HISTORIC DISTRICT REVIEW BOARD

Wednesday, July 8, 2020, 2:00 P.M.

A. **Justice Square, 1409 King Street, PIN R120 004 000 1009 0000,** Alterations, Additions, New Construction

B. **501 Carteret Street, PIN R120 004 000 0731 0000,** Alterations, Additions

TREE REMOVAL DIAGRAM

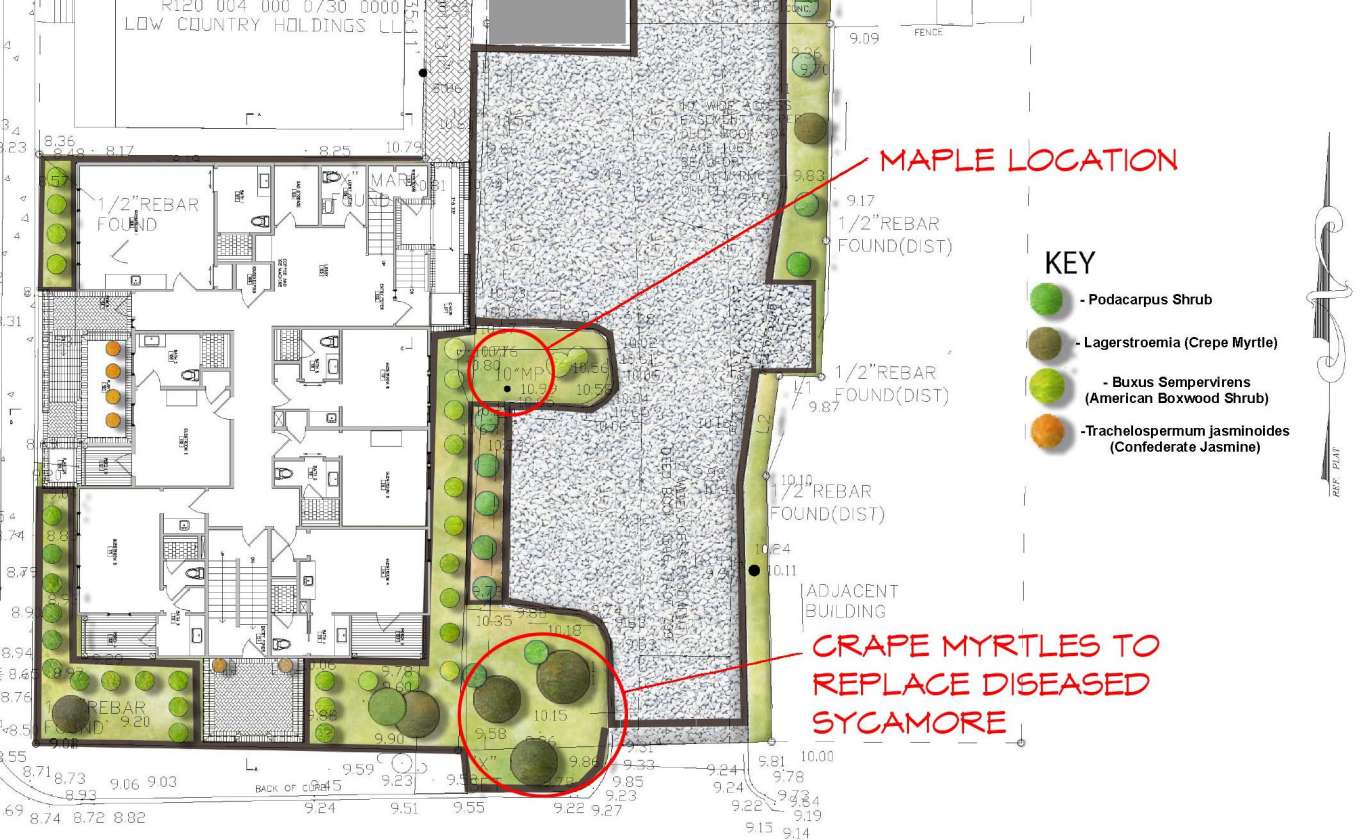
Landscaping Plan item 1: *If any trees are to be removed, applicant should identify them or state that none will be removed.*

There are (2) trees we wish to remove: a Sycamore near the entrance on North St. and a small Maple in a parking peninsula on the West side of the building. The Sycamore has a significant percentage of dead limbs, and the landscape plan has (3) Crape Myrtles planned to replace it. The small maple behind the building is not a strong specimen and the peninsula it occupies will be re-landscaped to provide a much more inviting main guest entry. See sheet 2.3, the annotated Landscape Plan, and tree photographs.
